Subject: Calvert Cliffs Nuclear Power Plant, Units Nos. 1 & 2
Docket Nos. 50-317 & 50-318
Request for Amendments

TECHNICAL SPECIFICATION CHANGES

Change No. 1 (FCR 81-1037)

Change No. 2 (FCR 81-1036):

FIGURE 1 - ARRANGEMENT -
RESERVE BATTERY

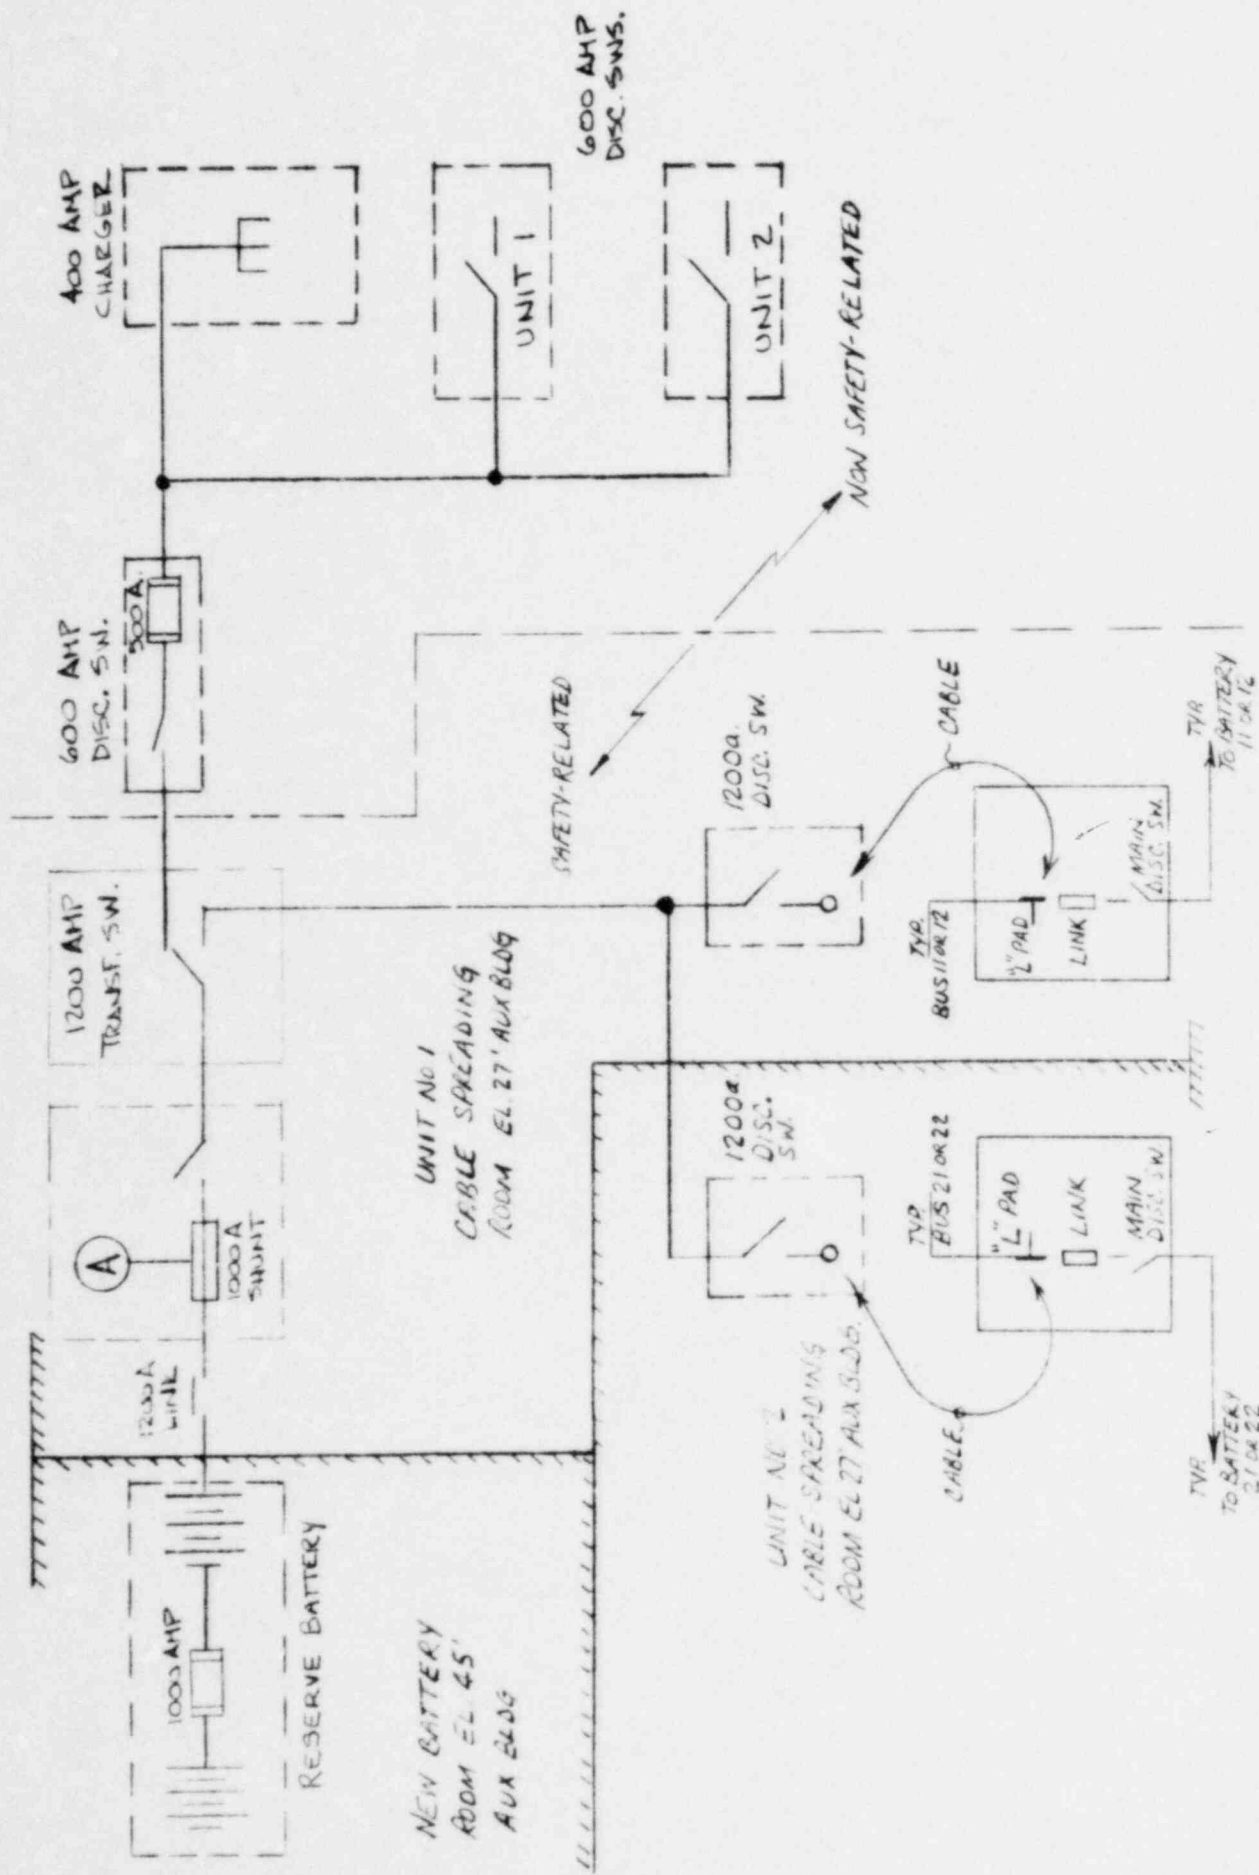
We have completed the installation of the battery, now designated the Reserve Battery, in its permanent location, a new battery room on elevation 45' of the Auxiliary Building. The details of the installation are provided in Attachment 1 and Figure 1.

The Reserve battery system basically includes a 1500 Ahr. fully qualified battery, a 1200 ampere transfer switch and 1200 ampere disconnect switches. (See Figure 1) The charger and its associated disconnect switches are non-safety related since they will never be electrically connected to the safety-related systems. The Reserve Battery is on a continuous float charge until which time it is transferred from the charger to the load.

The new system has been installed such that no permanent connections were made to the existing 125 VDC buses. This will guarantee no cross-connections between any of the 4 safety-related busses each of which is a different separation group. At the time of the Reserve battery use as a replacement for one of the four vital batteries, cables will be connected between the respective unit's 1200 ampere disconnect switch and the bus of the battery being replaced. Only one set of these cables have been fabricated, ensuring only one 125 VDC bus can be connected at a time to the Reserve battery. With the exception of this set of cables, the entire safety related portion of the Reserve battery system is permanently installed and available for use. This arrangement of a set of cables being utilized for the final connection to the 125 VDC bus, ensures compliance with the plant's single failure criteria.

All switching equipment is located in the cable spreading room, Elevation 27, where the existing DC Switchgear is located. The Reserve battery is permanently located in a new battery room on Elevation 45' in the Auxiliary Building. This room sits directly over the cable spreading room which allows the shortest possible cable run in conduit to the switching equipment. The Reserve battery is enclosed with three (3) hour fire-rated walls. The Reserve battery room has sufficient ventilation and has fire and air flow detectors.
